ORDER OF POLKA DOTS SUBDIVISION, REVISED

APPLICATION NUMBER 1 DATE January 5, 2023
 APPLICANT Order of Polka Dots Subdivision, Revised
 REQUEST Subdivision

DETAIL SITE PLAN

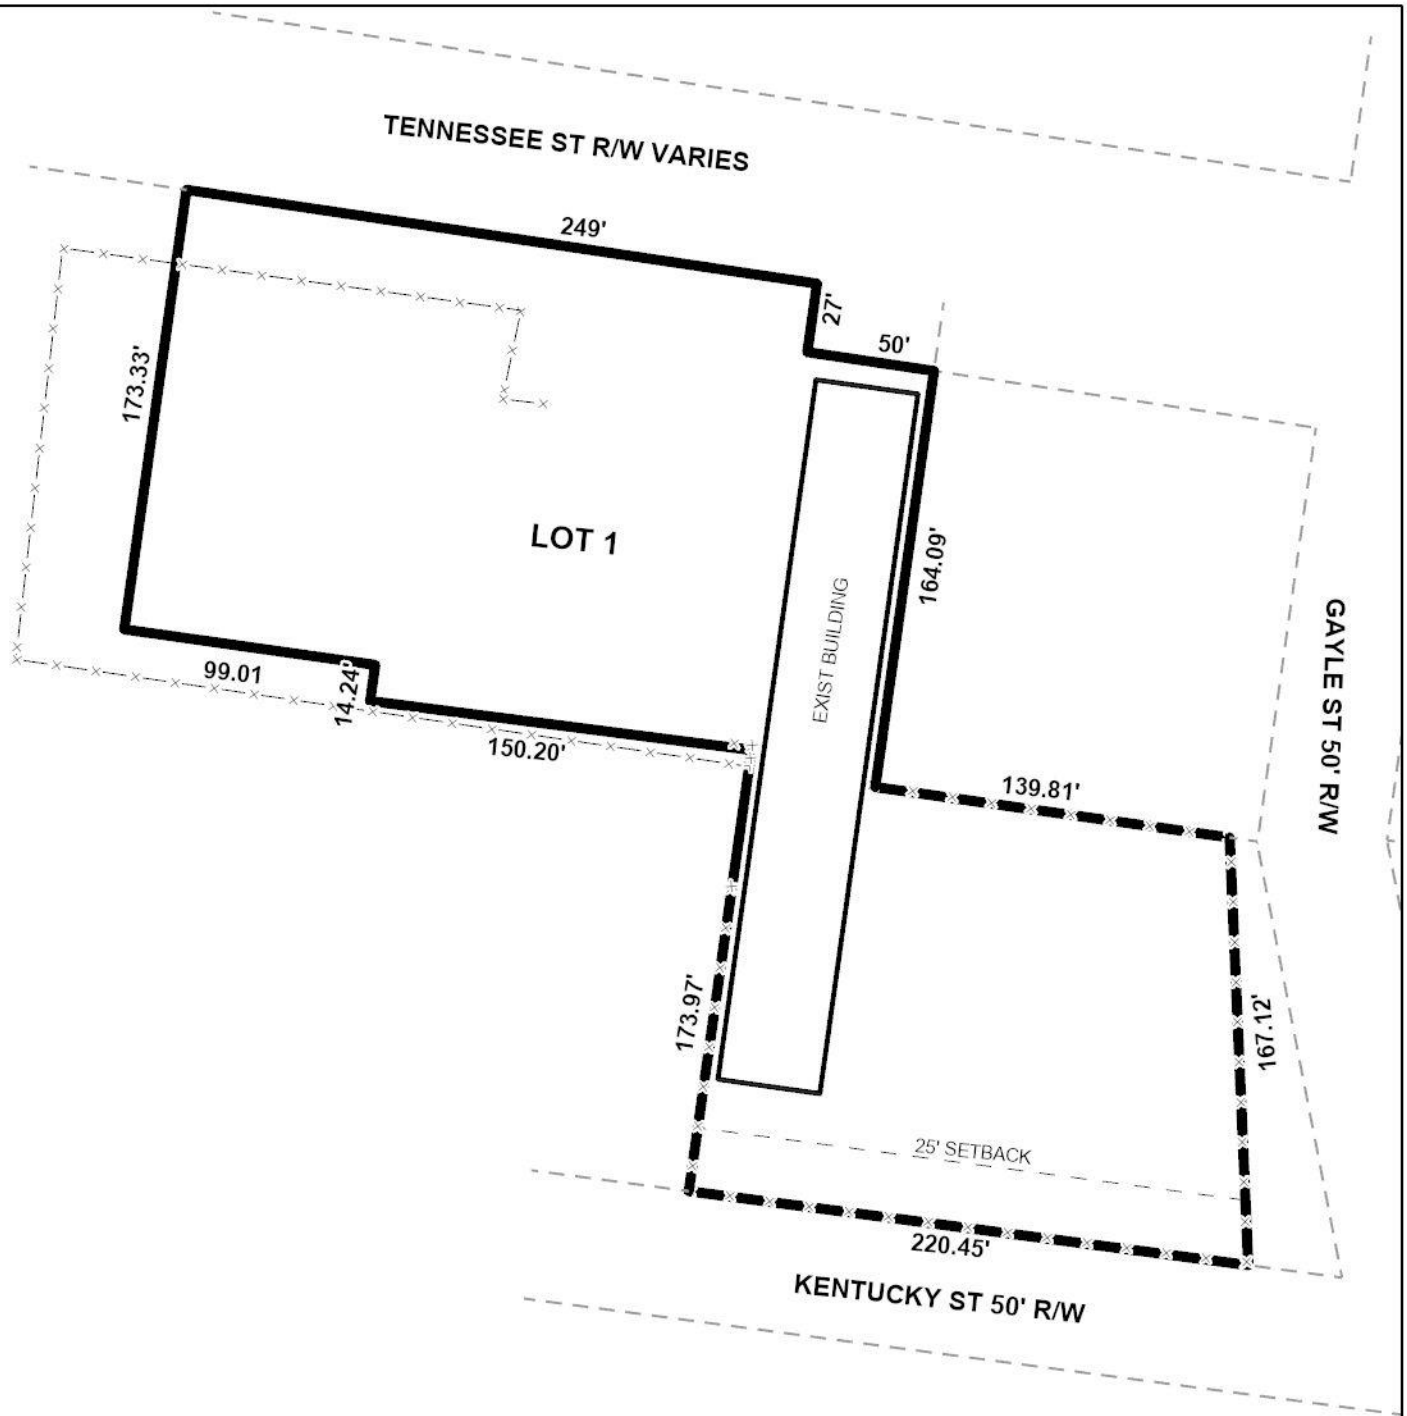
The preliminary plat submitted illustrates a proposed 25-foot minimum building setback line along Kentucky Street, which meets the minimum building setback line required by Section V.D.9 of the Subdivision Regulations. The preliminary plat does not illustrate the 25-foot minimum setback line along Gayle Street or Tennessee Street. If approved, the 25-foot minimum building setback lines along Kentucky Street should be retained and should be illustrated along Gayle Street and Tennessee Street on the Final Plat, and should be adjusted to accommodate any required dedication.

The proposed subdivision is irregularly shaped which is discouraged by Section V.D.1. of the Subdivision Regulations. The exception being approval of the lot located where varied and irregularly-shaped lots are common, and the informality of the design is consistent with other lots in the vicinity, as is the case with the subject site.

- 1) Retention of the right-of-way widths of Gayle Street on the Final Plat;
- 2) Dedication to provide 30 feet to the centerline of Tennessee Street and Kentucky Street;
- 3) Dedication of corner radius
- 4) Illustrate the 25-foot minimum building setback line along all rights-of-way, adjusted for dedication;
